**PLANNING COMMISSION MEETING
THURSDAY, SEPTEMBER 8, 2022**

**DOCUMENTS RECEIVED AFTER
PUBLISHED AGENDA**

Proposed Vesting Tentative Tract Map (Tract 8461) Application No. 202004359 for a 40-unit Townhouse-Style Residential Condominium on a Vacant 1.66-acre Site located at 21339-21447 Oak Street for which a Corresponding Site Plan Review Application (201800932) was Previously Approved in 2019 – Oak Street Townhomes

Additional Comments from Grove Way Neighborhood Association regarding
Hayward Site Plan Review No. 201800932 (21339, 21377, 21385, 21407, 21425, 21431, and 21447 Oak Street)

Figure 2) Hayward Land Use Diagram (2040 General Plan)

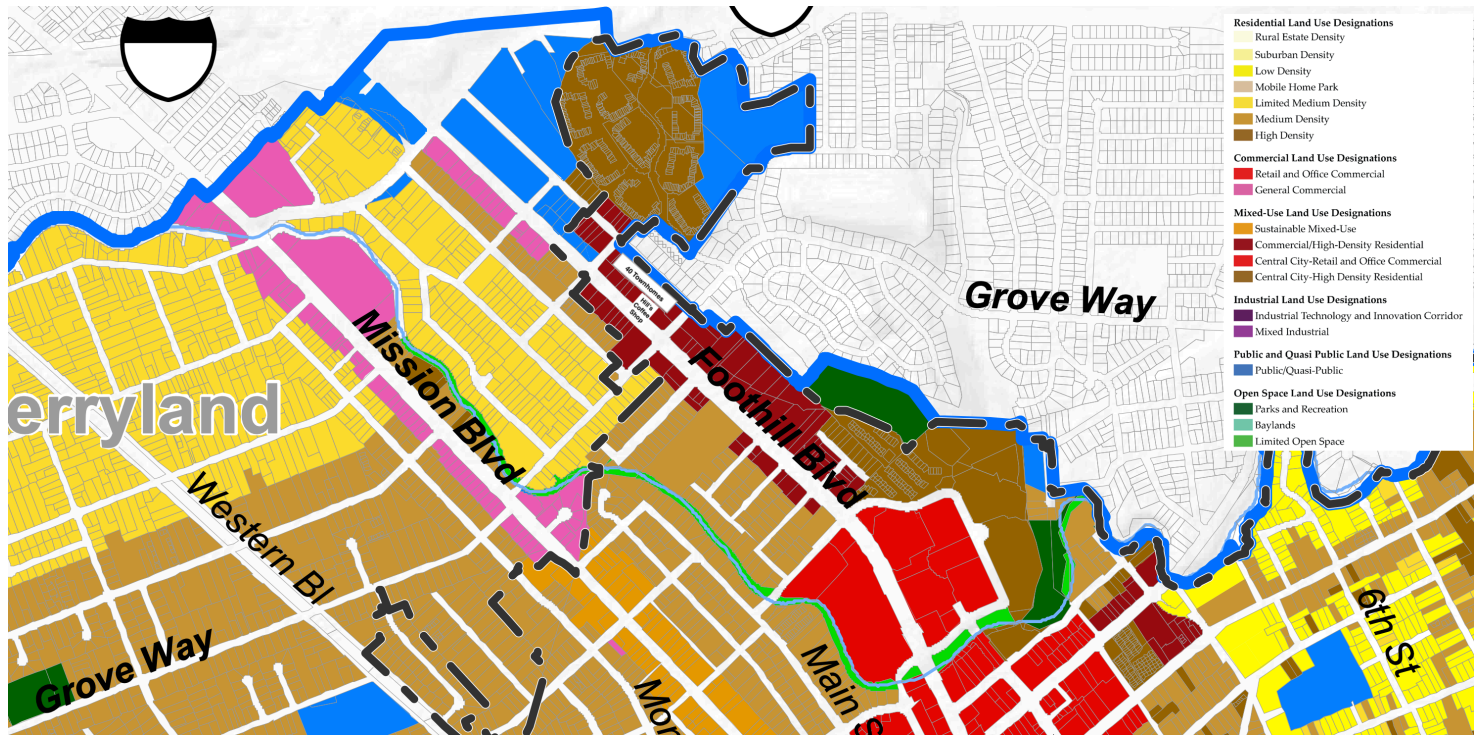
The Hayward 2040 General Plan land use designation gives a general guide to the intended land use and does not reflect the current use. It indicates that Oak Street is intended for Commercial/High Density Residential type of buildings (Figure 2). From the 2040 General Plan: *Future changes to Commercial/High Density Residential areas are expected to include enhancements that create more pedestrian-oriented commercial centers and multi-modal corridors.*

Figure 2) Oak Street Plan Modified for Pedestrian Gate to Foothill Businesses

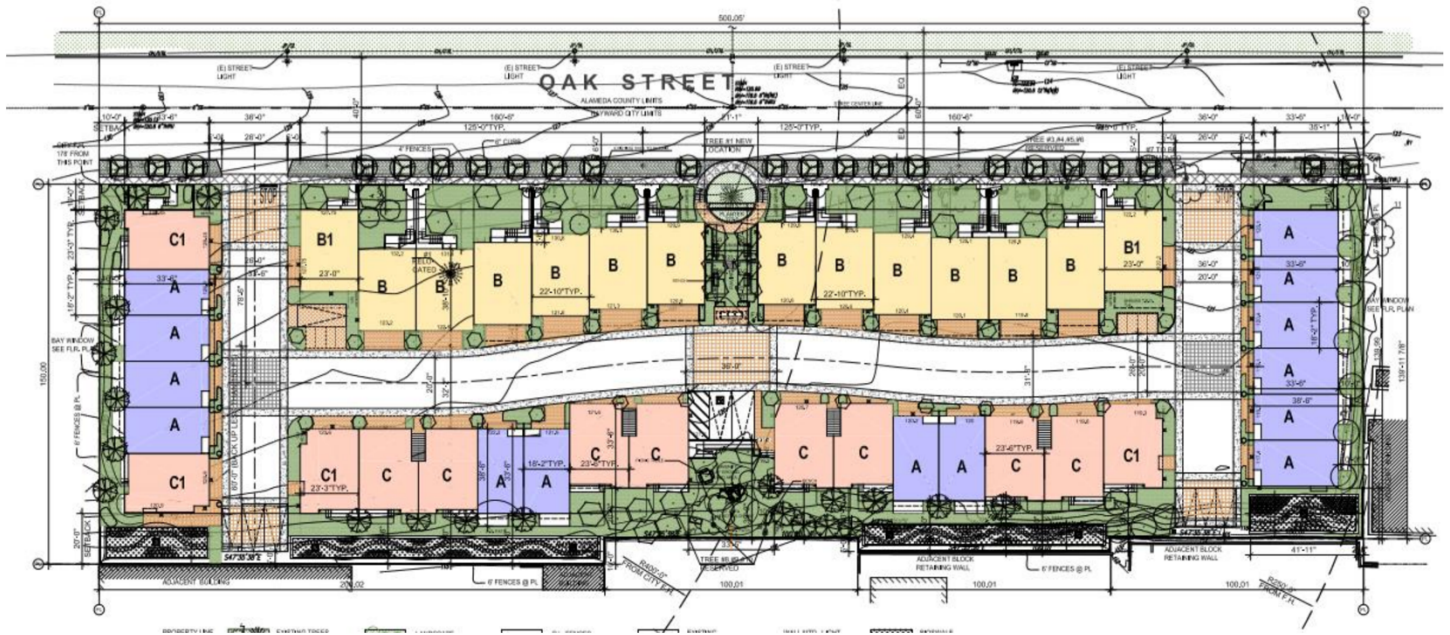
One big suggestion (Figures 3 and 4) is to incorporate a pedestrian gate to the Hill's Coffee Shop parking lot. Foothill Boulevard is very loud, busy, and unpleasant to walk on. Hill's is a highly-rated breakfast and lunch coffee shop that future residents will not be able to access without either driving or walking out Oak Street to Grove Way to Foothill Boulevard. There is no reason that the development must be symmetrical, especially when that configuration does not blend with the adjacent buildings or add a pedestrian feature. By simply moving the open space area, a gateway could be created at the rear of the open space, allowing residents to easily access the coffee shop. Neighbors were previously able to access Hill's Coffee Shop through this route before the chain link fences were installed.

The gate at the rear of the complex can remain secure by providing only an exit, unless the pedestrian has a key, or code, to enter the development from Hill's parking lot. The pedestrian gate would also provide a rear emergency exit which does not exist in the current plans.

If the open space is not moved, and a gated opening is not provided, the Hill's parking lot will be terminate in the development's concrete retaining wall with non-native flowering cherry trees above. This is not a pleasant view, but could be easily improved by considering the way that the area is currently used by pedestrians. Hill's and its neighboring liquor store have a high volume of traffic.
